GALION BAY DAM
(LAKE RENE)
NDI I.D. NO: PA-747
DER I.D. NO: 17-107

PHASE I INSPECTION REPORT
NATIONAL DAM INSPECTION PROGRAM

BY
D'APPOLONIA CONSULTING ENGINEERS
10 DUFF ROAD
PITTSBURGH, PA. 15235
JUNE 1979

PLATE 2

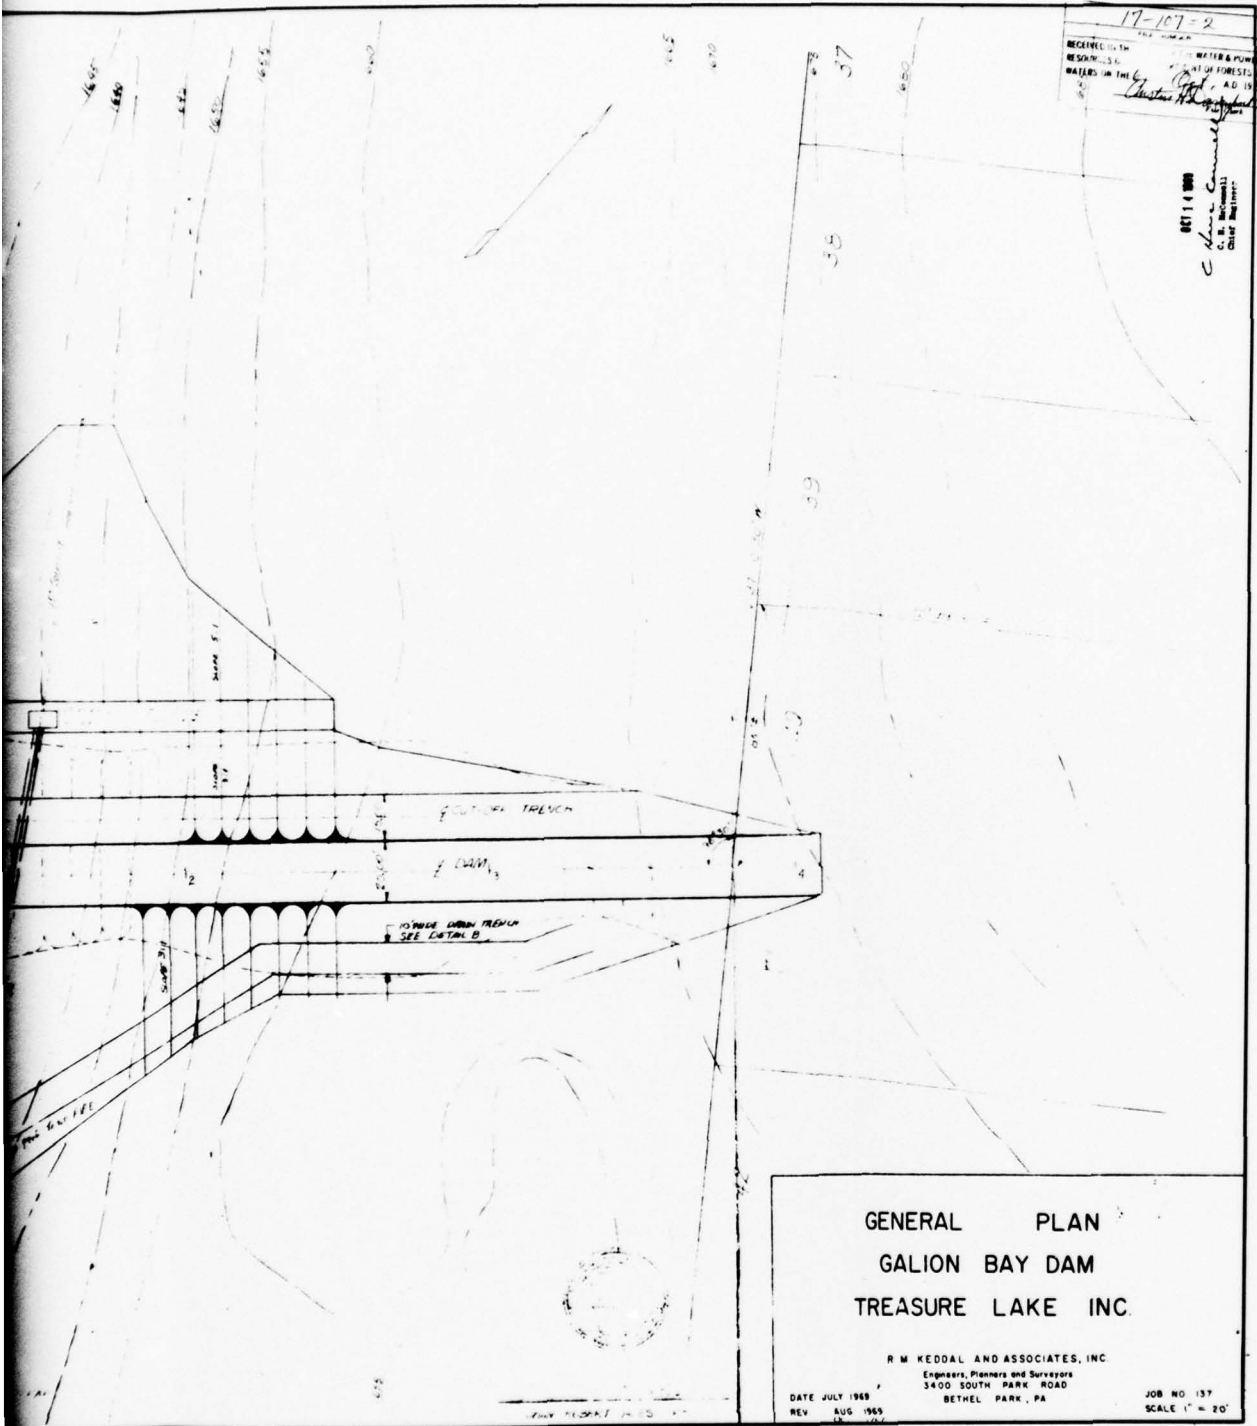
- a. As designed, the dam (Plate 2) is a zoned embankment (Plate 3) with an impervious core extending through a cutoff trench to top of rock and an internal drainage system beneath the downstream slope. Two zones are identified. The first zone is an impervious zone and forms the core of the embankment. The second zone is a semi-impervious zone and constitutes the shell sections of the embankment. The impervious core zone is trapezoidal in cross section and starts at a level five feet below the crest of the dam and extends through the cutoff trench to the top of rock. The internal drainage system consists of a trench drain along the downstream toe of the embankment. The trench drain is shown to be equipped with a perforated pipe which discharges into the outlet works discharge channel .

The emergency spillway is a trapezoidal earth channel excavated into the right abutment (Plate 2). The bottom width of the trapezoidal channel is 30 feet with side slopes of 2H to 1V. A 30-foot-wide level section located at Elevation 1664.5 in line with the axis of the embankment constitutes the control section of the spillway.

PLATE 8
GALION BAY DAM
GENERAL PLAN
FIELD INSPECTION NOTES
FIELD INSPECTION DATE: APR. 3, 79

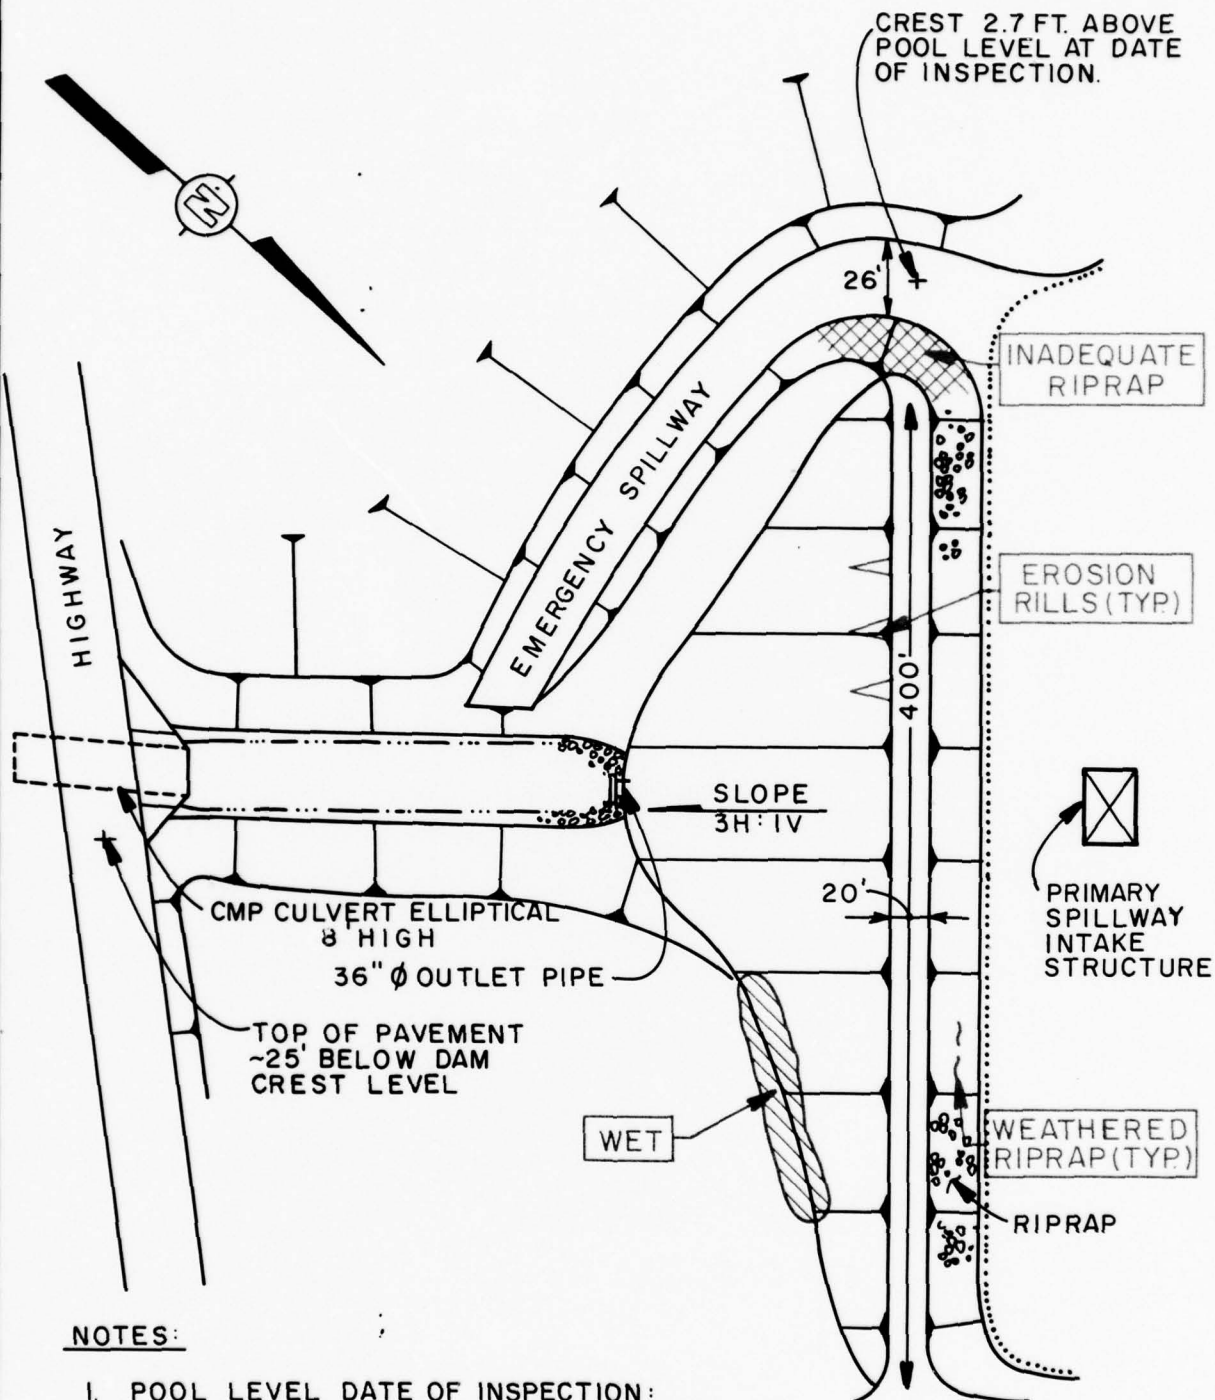
The specific observations are illustrated in Plate 8 and in the photographs in Appendix C.

In general, the condition of the dam is considered to be good. One wet area was found along the toe of the dam near the left abutment. No measurable seepage was found to be associated with this wet area. Riprap on the upstream face was found to be partially deteriorated; however, it is still providing adequate erosion protection.

3.2 Evaluation. The condition of the dam is considered to be good. The present extent of the wet area along the toe of the dam near the left abutment does not appear to be affecting the stability of the embankment at this time. Installation of additional riprap on the embankment side of the emergency spillway discharge channel is recommended to avoid embankment erosion during large flows through the emergency spillway.

1. Adequate erosion protection should be provided on the embankment (left) side of the emergency spillway discharge channel to protect the embankment from eroding during flows through the emergency spillway.
2. Around-the-clock surveillance should be provided during unusually heavy runoff and a formal warning system should be developed to alert downstream residents in the event of emergencies.
3. The dam and appurtenant structures should be inspected regularly and necessary maintenance should be performed.

PLATE 9

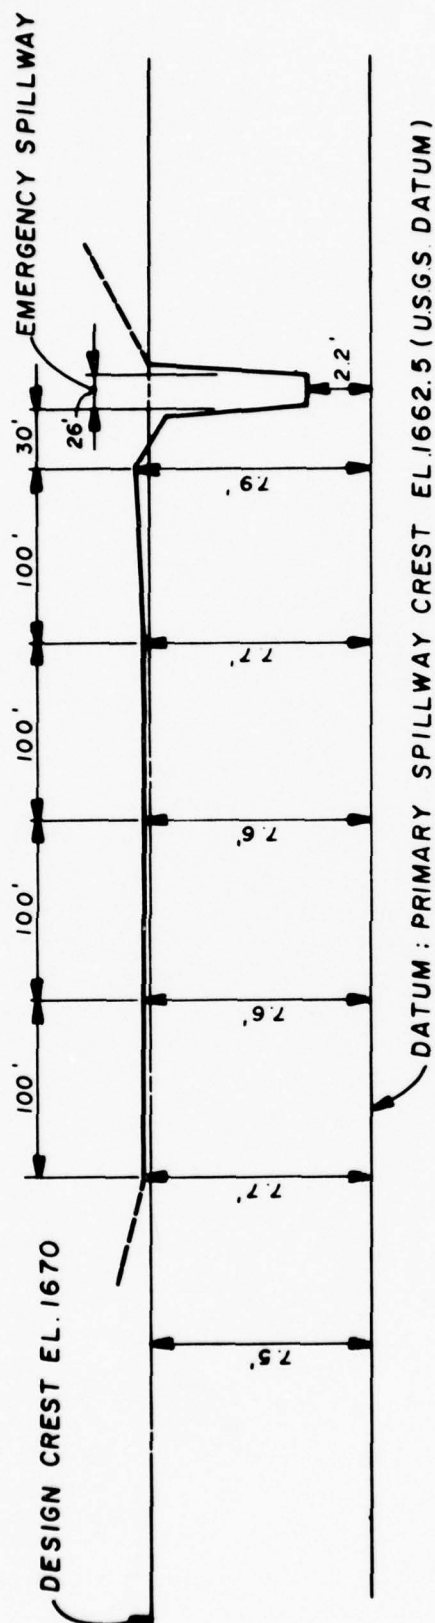
The top of the embankment was surveyed relative to the pool level on the date of inspection, which was estimated at Elevation 1662.6 and the lowest area on the crest of the embankment was found to be within 0.1 foot above the design elevation of 1670. The dam crest profile is illustrated on Plate 9.
